REGARDING: Basin Perlite Company - Mine Permit Revision  
MESSAGE: Here is a draft of our reply to your  
Review dated 6/25/01.

Reference is made to your "Fourth Review of Intention to Commence Large Mining Operations", Basin Perlite Company, Pearl Queen Mine M/001/027, Beaver County, Utah. This Review was dated June 12, 2001.

**Reply to Fourth Review of Notice of Intention to Revise Mining Operations, Basin Perlite Company, Pearl Queen Mine M/001/027, Beaver County Utah, Dated June 12, 2001.**

## 111.8 All roads and pads reclaimed

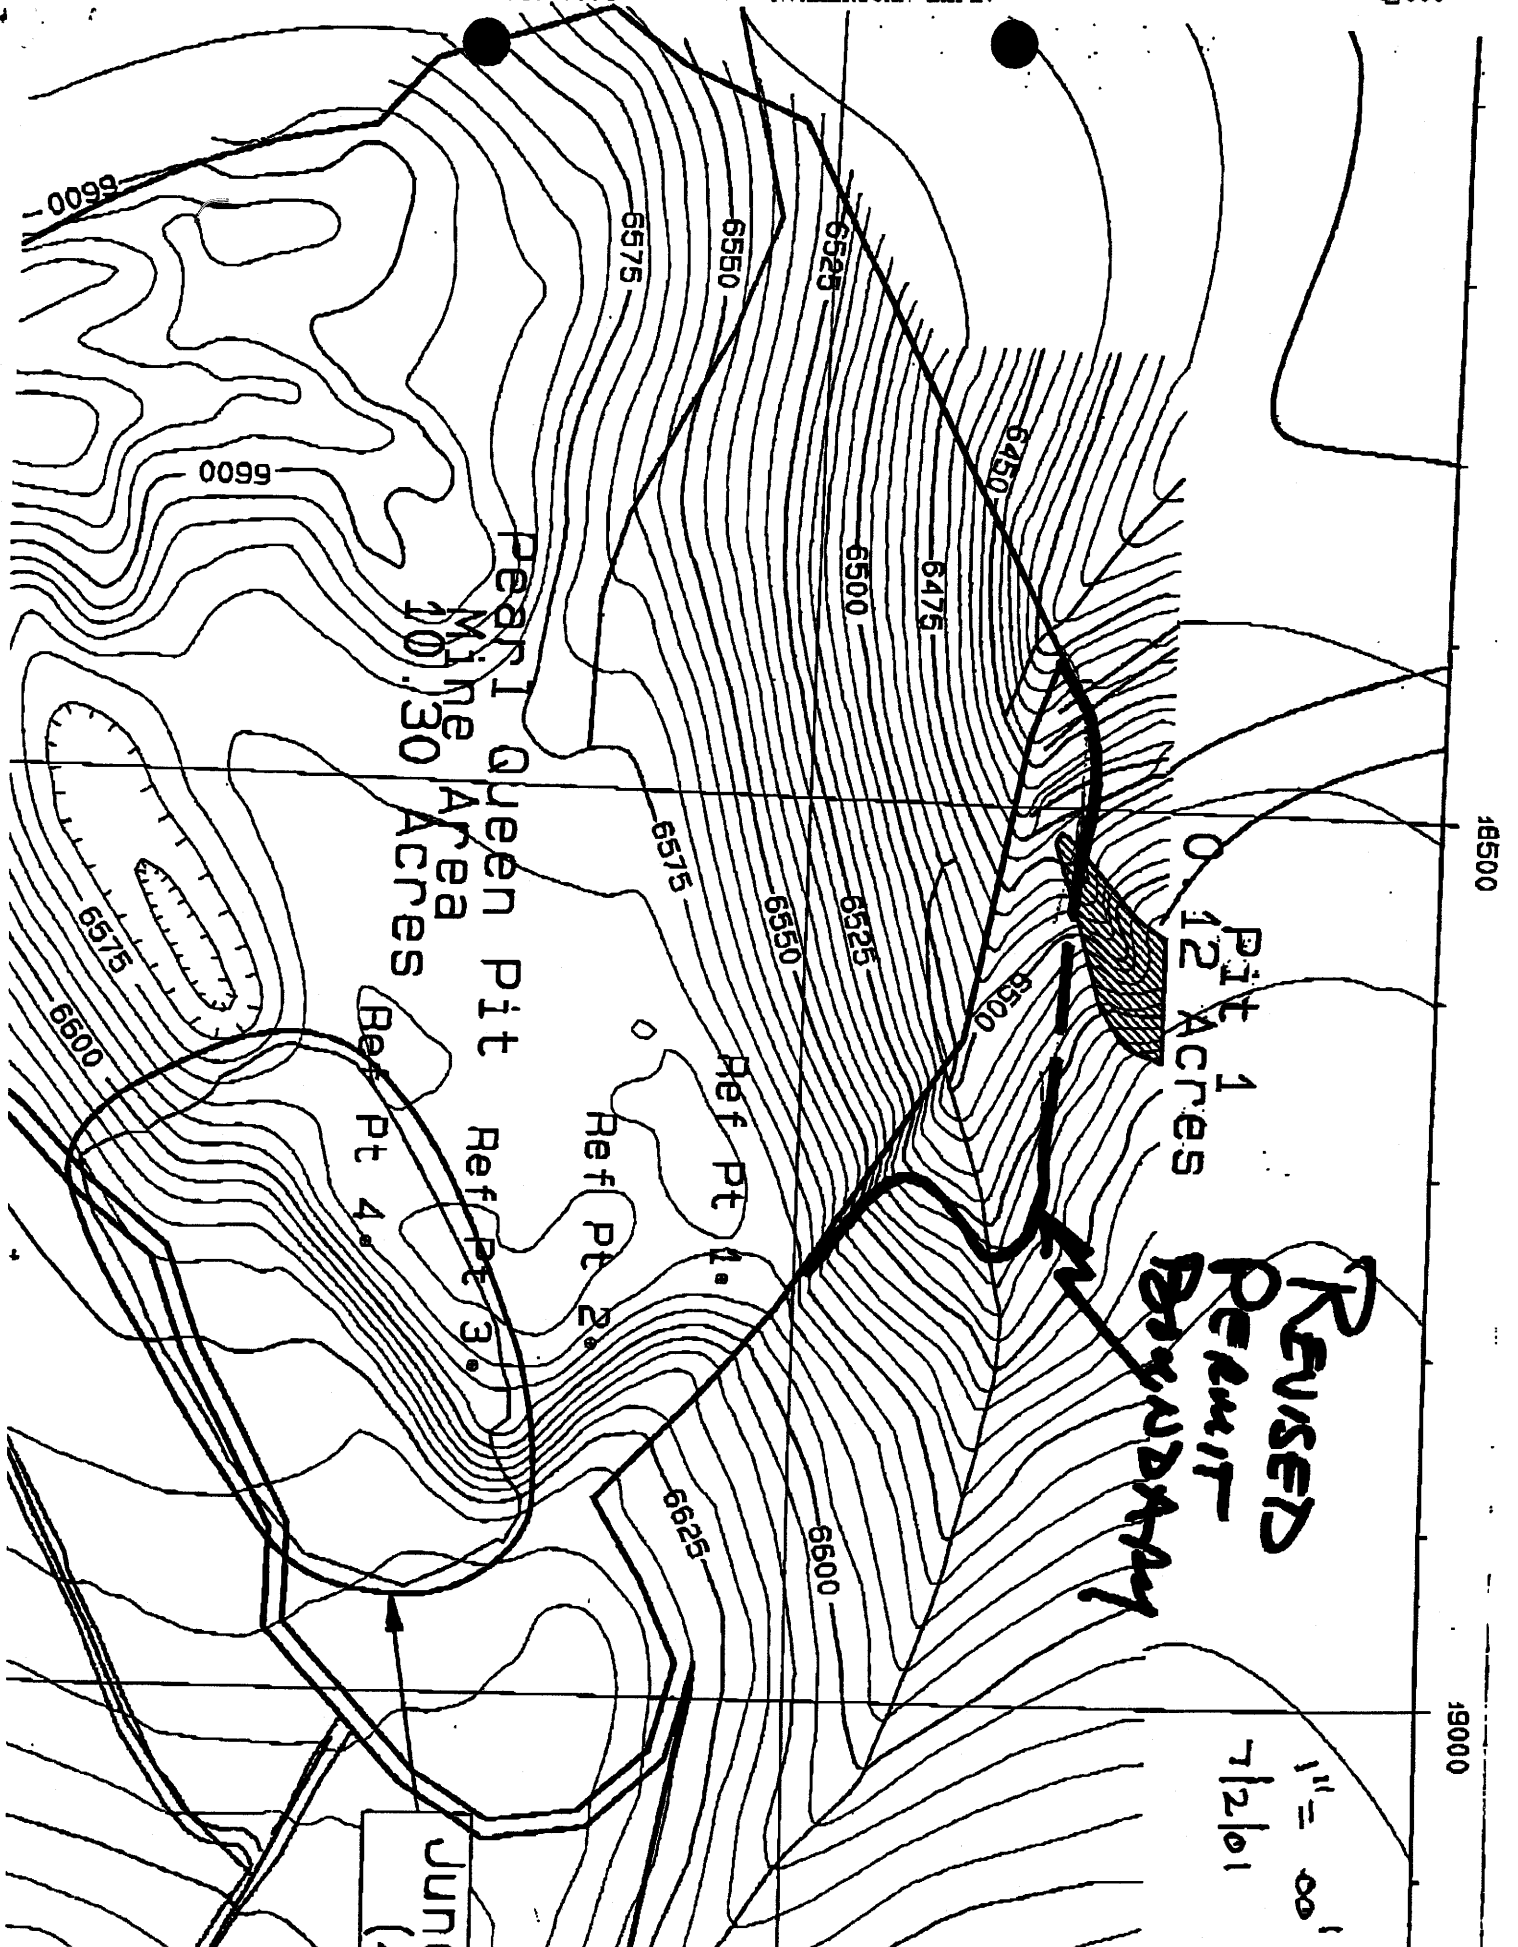
We will not widen or realign the road to Pit No. 3 (Schoo Pit).
